PHASE SPECIFIC CONSUMPTION FOR OVC- HEV BASED ON THE PROPOSAL FROM JAPAN.

PHASE SPECIFIC CONSUMPTION FOR OVC-HEV.

JAPANESE APPROACH FOR PHASE SPECIFIC CONSUMPTIONS AND RANGES.

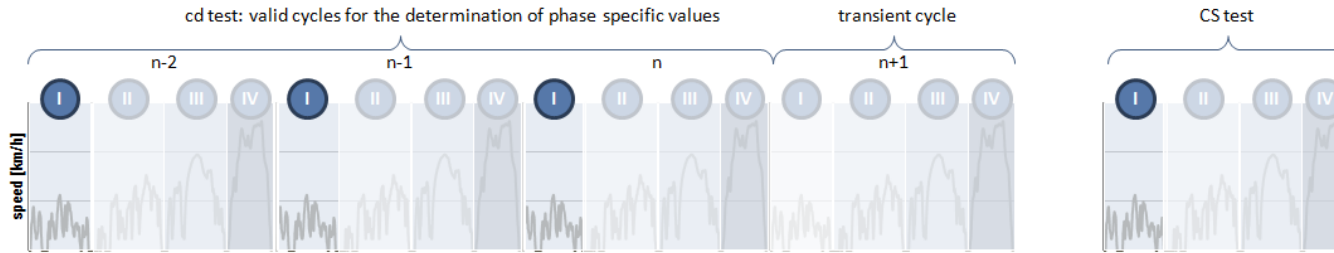
R: ► The approach can only be applied to vehicles that are able to drive the whole first cycle in charge depleting because the transient cycle has to be excluded for the determination of the electric consumption to calculate the estimated electric range for the specific phase.

Q: ► How to handle with vehicles that are able to drive a transient cycle only?

Q: ► How big is the impact of the "cold start" conditions if only one cycle can be used because the second one is a transient cycle?

Proposed calculation formula doesn't take care of such a vehicle. Thank you for your feedback. Need to consider the alternative method for those vehicles.

In that case a proposal could be to drive each phase separately. → higher test burden for such kind of vehicles

It depends on the system, however, it has negative impact on performance value. It's OK for us to have an option to run the consecutive each phase test (L-L-L-L..., M-M-M-M...,) as an option.

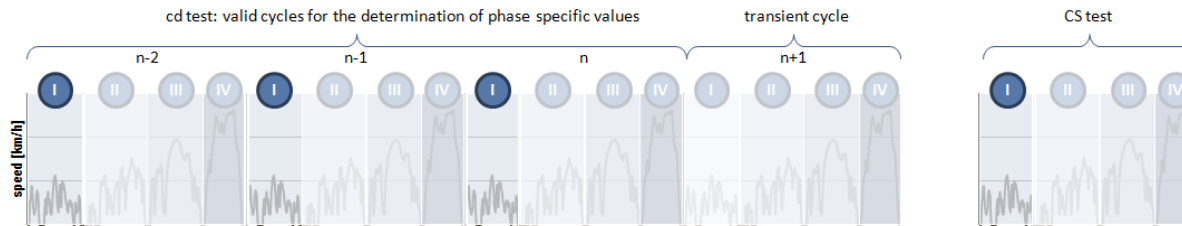
R: ► RCB-correction for each phase in charge sustaining is necessary! That is not required in the GTR now!

If the RCB correction is not required because the test is within the tolerance, the low and mid CO₂ will be lower and the high and extraHigh CO₂ will be higher than the value that would be determined by driving consecutive each phase cycles.

If no correction is necessary for whole cycle, no correction is required for each phase as basis. It's OK to allow manufacturer to develop each phase correction factor.

1.) First solution:

Each phase measurement .→ Disadvantage of higher test burden. → Is not recommended by the ACEA.

2.) Second solution:

An approach for each phase RCB-correction is to use the cycle energy. The energy demand over the whole cycle and the energy demand over each phase leads to an each phase percentage that can be used to calculate the each phase consumption by multiplication of each phase percentage and whole cycle consumption (nearly SOC neutral). BMW will work on a proposal for that issue.

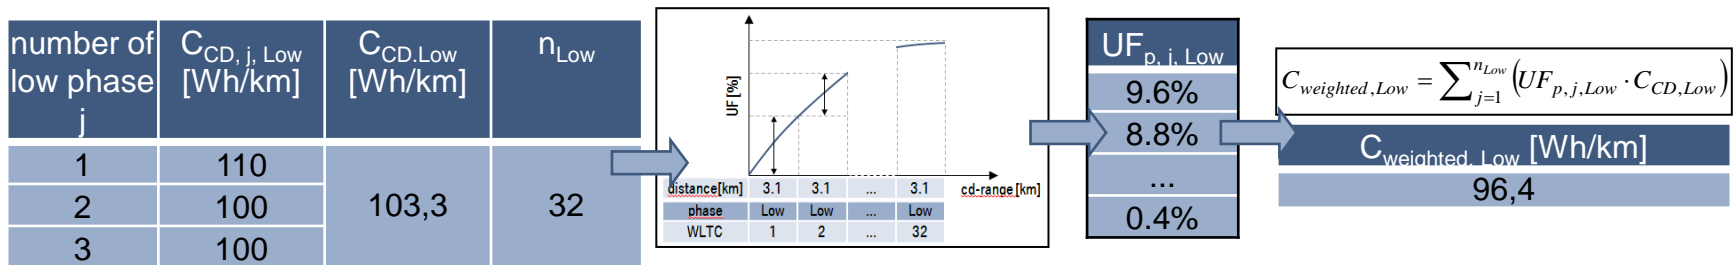
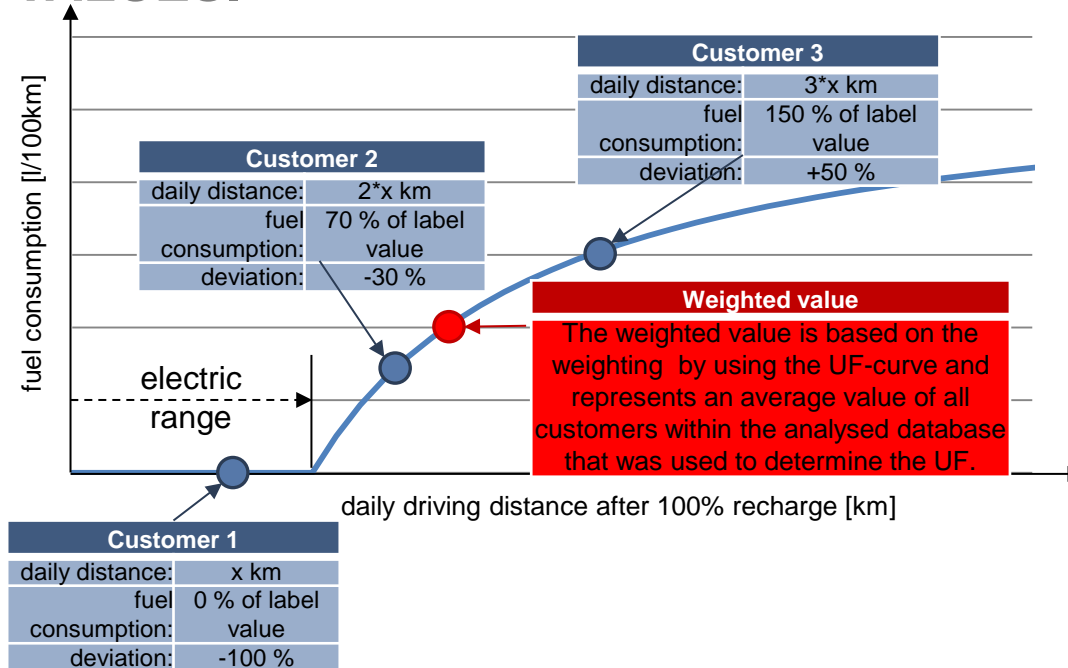
R: ► Is it valid to use the same UF curve for the weighting of each phase consumptions or do we need more criteria concerning the analysis of databases to determine a UF curve for the low, mid, high and exHigh – phase (e.g. a filter that distinguishes between urban and non-urban drive)!

A: We've made a decision to adopt regional UF for OVC-HEV calculation. Each region can adopt their own UF for also phase specific calculation. (JPN has only one UF and this UF is used for all kinds of calculation)

A: UF-weighted values are only made for the calculation of average fleet values. Each individual customer consumption hardly depends on the average daily driven distance.

→ ACEA proposes to delete the calculation of weighted each phase values.

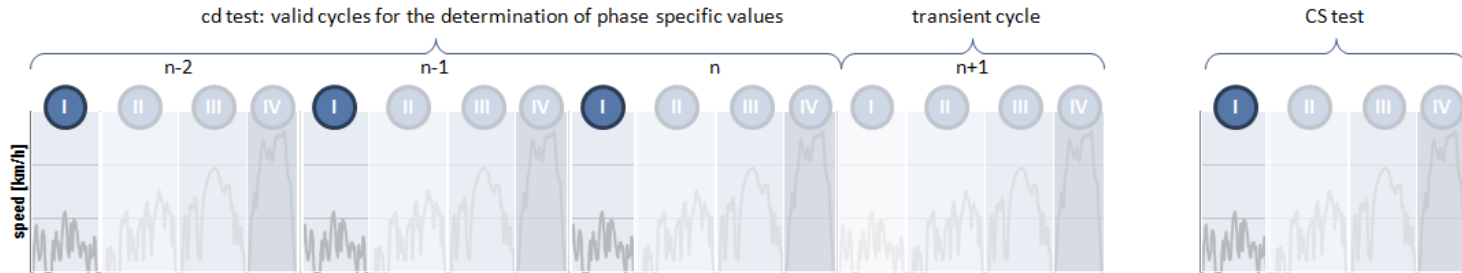
R: ► The figure shows the dependence from the daily driven distance of the customer concerning the fuel and electric consumption.

R: ► A weighted value is made to represent an average value for a fleet of vehicles, that can be used as a homologation value.

R: ► Using of separated values for charge depleting and charge sustaining mode for customer information.

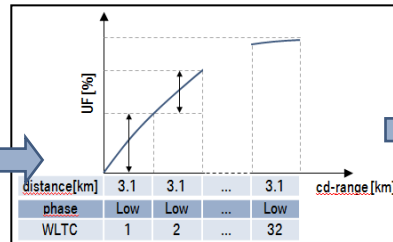
R: ► The recommendation from ACEA is to delete the calculation for the weighted each phase fuel consumption (as well as for the weighted electric consumption) because weighted values are not suitable for customer information (see slide 5 and 6).
